ADDENDUM NO. 1

Additions & Renovations to Pleasant Run Elementary School
1800 North Franklin Road
Indianapolis, IN 46219

PROJECT: PLEASANT RUN ELEMENTARY SCHOOL RENOVATION & ADDITION

PROJECT NO: 2020061

DRAWING TITLE:
FOUNDATION PLAN

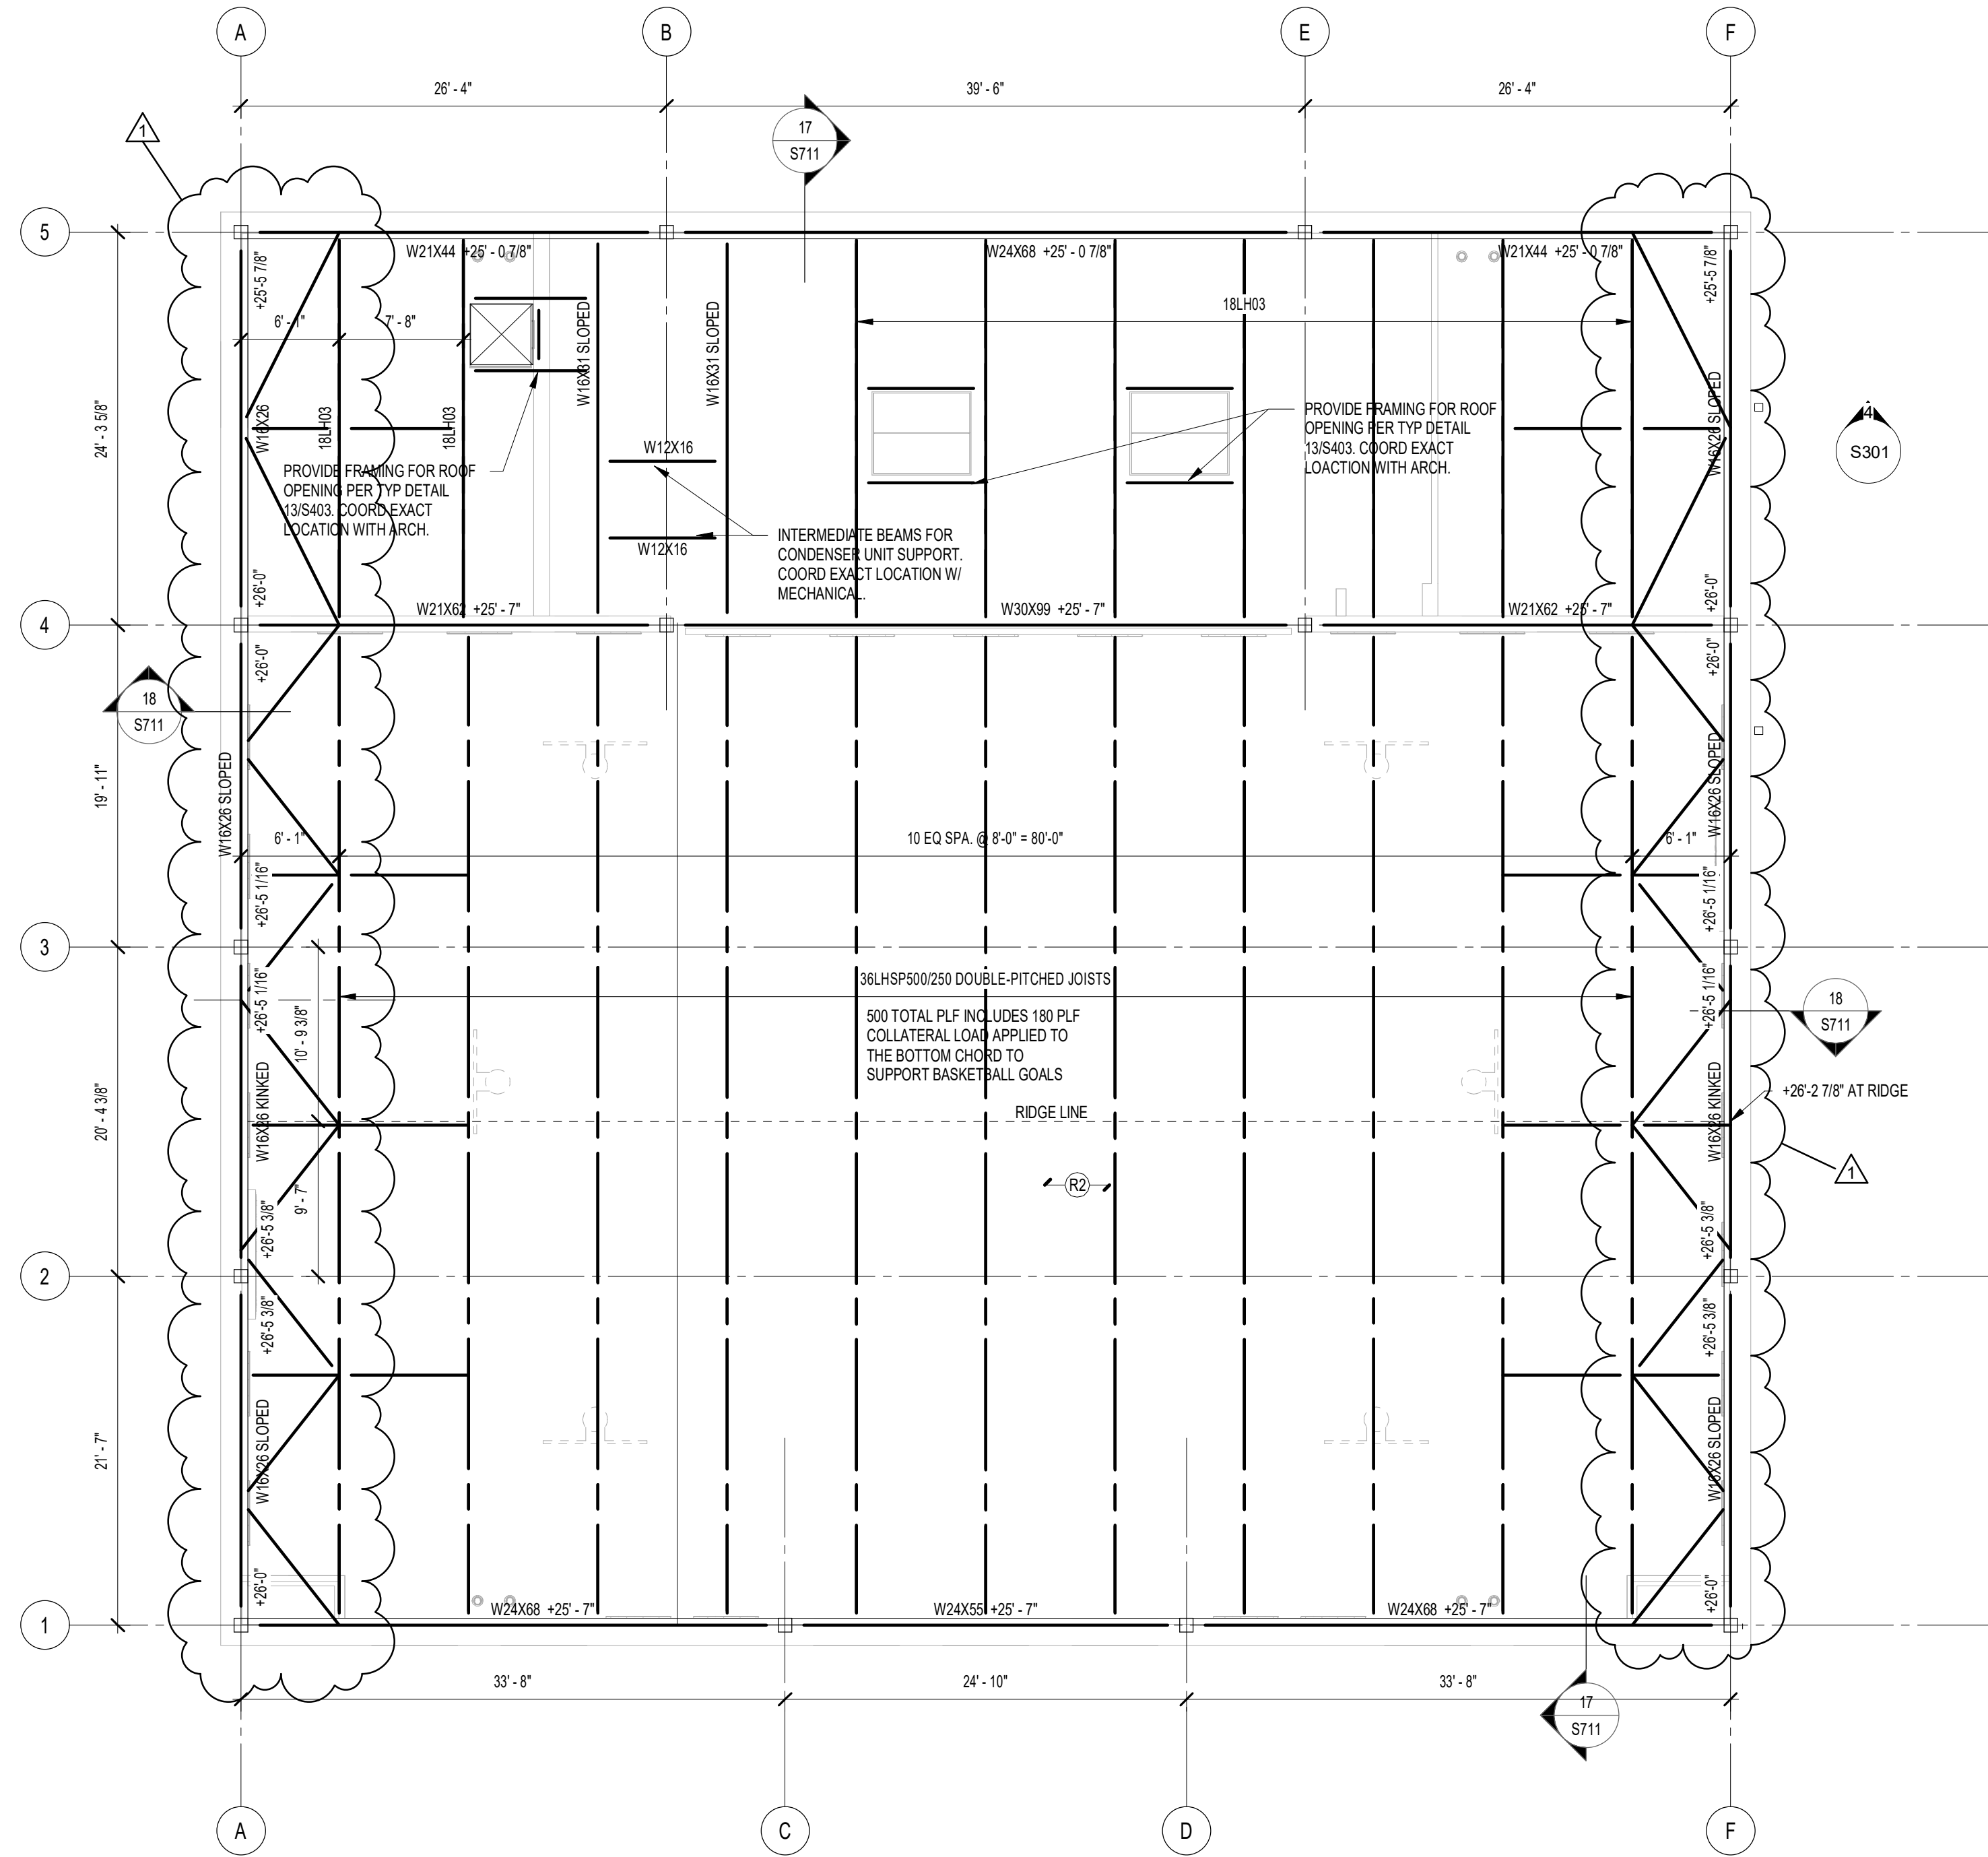
Drawing S101 Foundation Plan Unit B

1. Add foundation plan note clarifying "SP" footings.
2. Add more wall footings under CMU partition walls where slab on grade elevation changes.

DRAWING NUMBER
S103

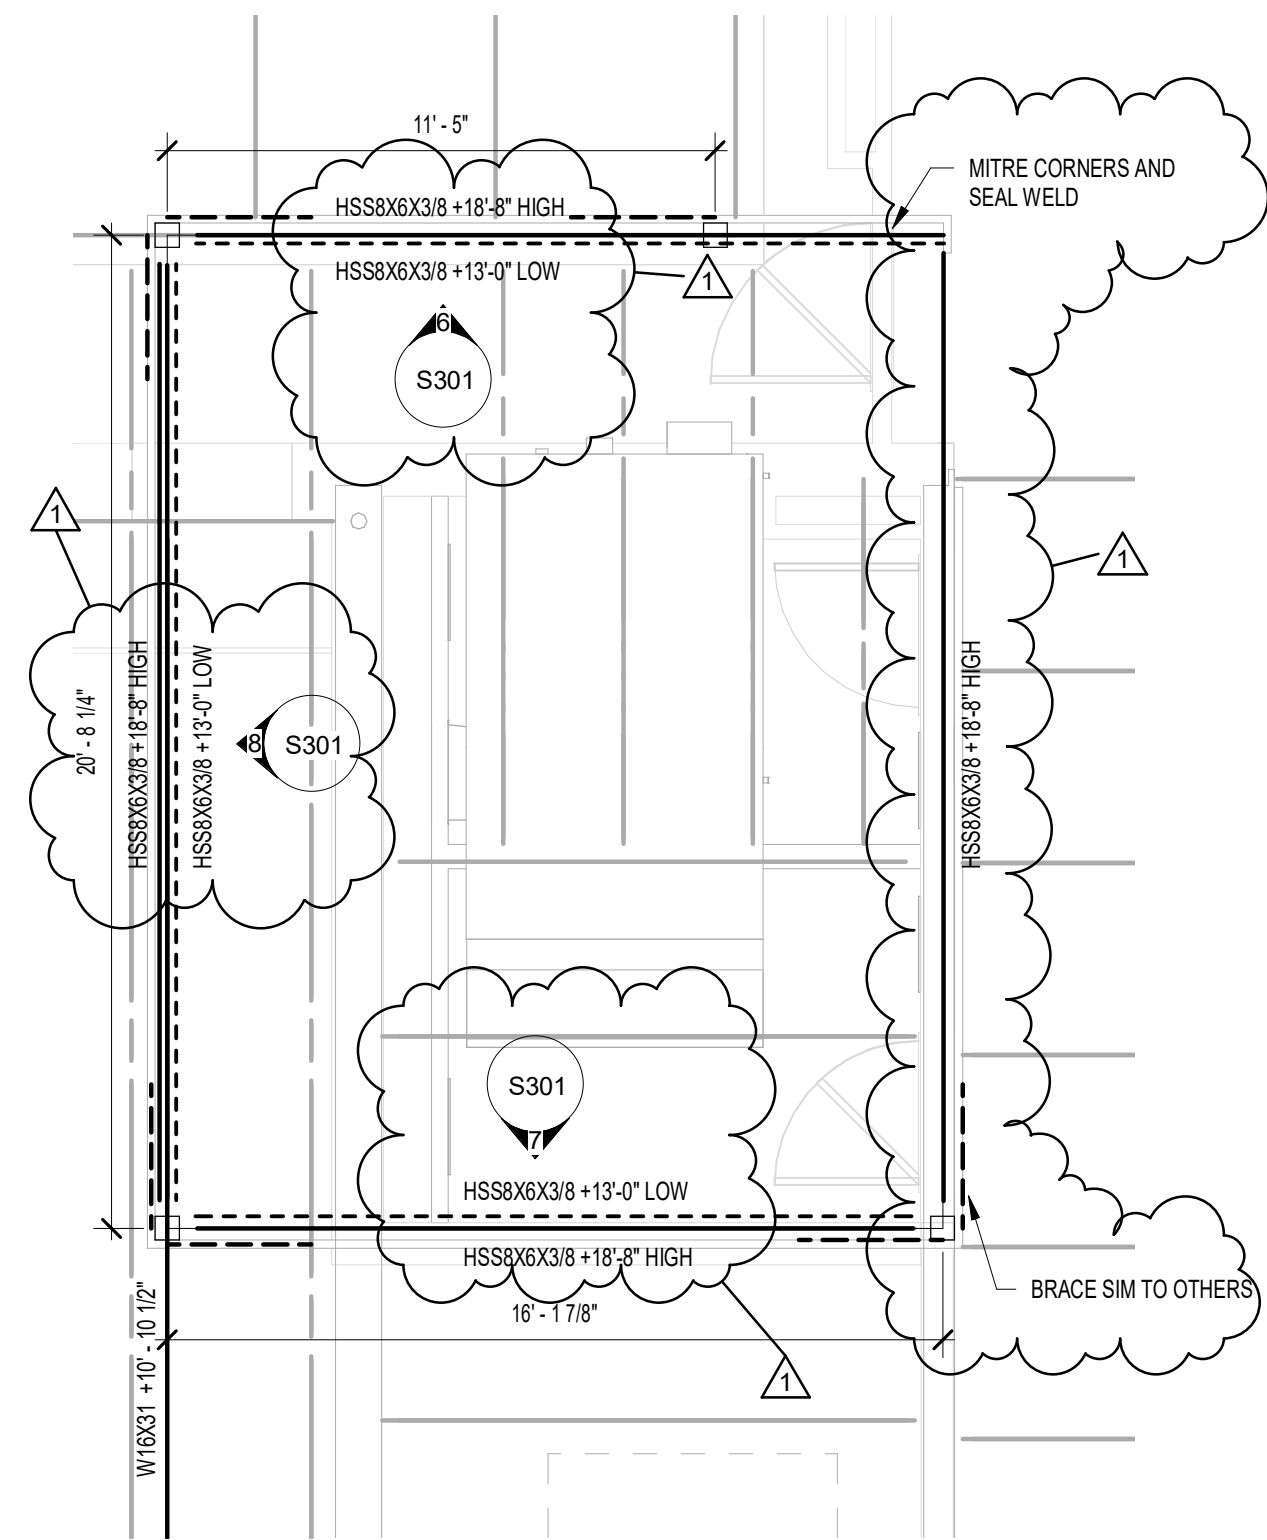
Drawing S103 Gym Roof Framing Plan Unit B

1. Add WT4x12 horizontal bracing in last bay of roof for diaphragm support.
